Intel[®] Mobile Pentium[®] III Processor Specification Update

Release Date: December 2000

Order Number: 245306-014

The Mobile Pentium[®] III processor may contain design defects or errors known as errata which may cause the product to deviate from published specifications. Current characterized errata are documented in this Specification Update.

Figure 7. BCLK Timing Waveform

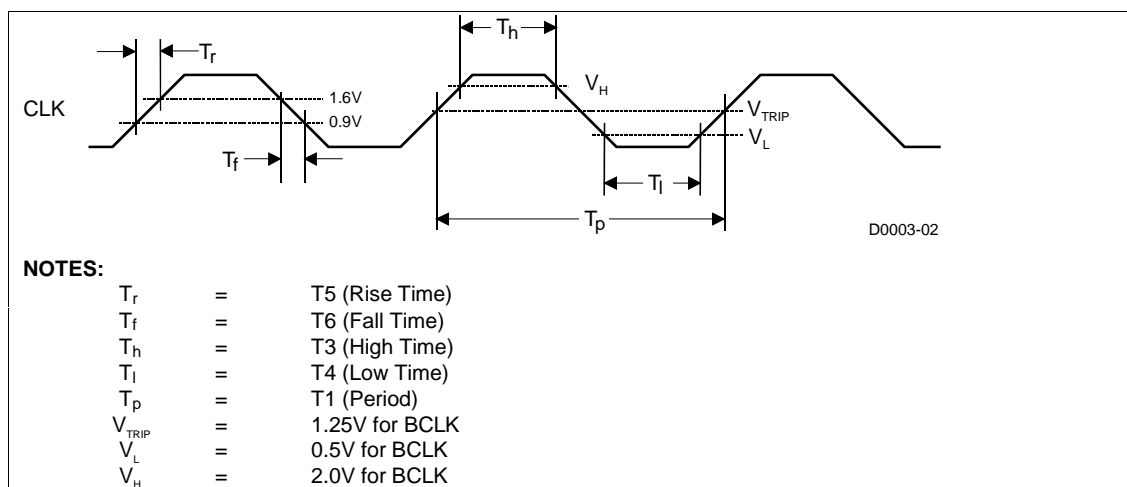
For B0 step processors, the $V_{IH,BCLK}$ Min spec is changed to 2.0V (from 1.7V for A2 step) and $V_{IL,BCLK}$ Max spec is changed to 0.5V (from 0.7V for A2 step). Due to this, new values are specified for BCLK high and low times for B0 step processors. These modifications affect corresponding specs in Table 13, Table 14, Table 24, and Figure 7 in *Mobile Pentium® III Processor in BGA2 and Micro-PGA2 Packages datasheet* (Order Number 245302-002).

The following tables and figures highlight the above mentioned BSEL[1:0] and BCLK specs modifications made for B0 step processors:

Symbol	Parameter	Min	Typ	Max	Unit	Figure	Notes
	System Bus Frequency		100		MHz		
T1	BCLK Period		10		ns	Figure 7	Note 2
T2	BCLK Period Stability			± 250	ps		Notes 3, 4
T3	BCLK High Time	2.70			ns	Figure 7	at >2.0V
T4	BCLK Low Time	2.45			ns	Figure 7	at <0.5V
T5	BCLK Rise Time	0.175		0.875	ns	Figure 7	(0.9V – 1.6V)
T6	BCLK Fall Time	0.175		0.875	ns	Figure 7	(1.6V – 0.9V)
